X 86.105-26

MODEL 44

## IGNITION SYSTEM, IIDA-CIRCUIT

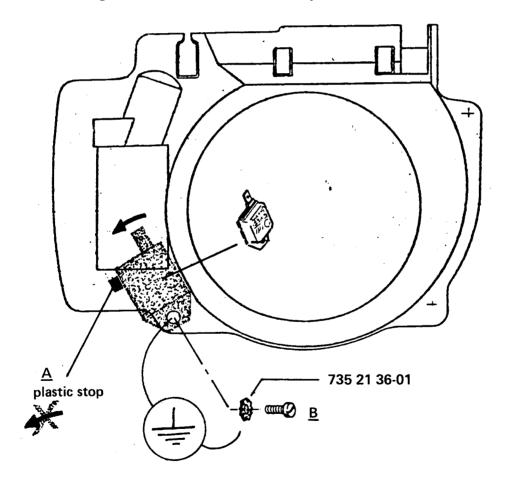
The following improvements have been made:

- A. The air conductor has been equipped with a plastic stop, which defines the lida-circuit in a firm position.
- <u>B.</u> The lida-circuit will be assembled with a lock washer. This gives a better grounding of the lida-circuit.

These measures give the saw an increased reliability.

$A \ from \ serial \ number \ 6040670$

B from serial number 5351301
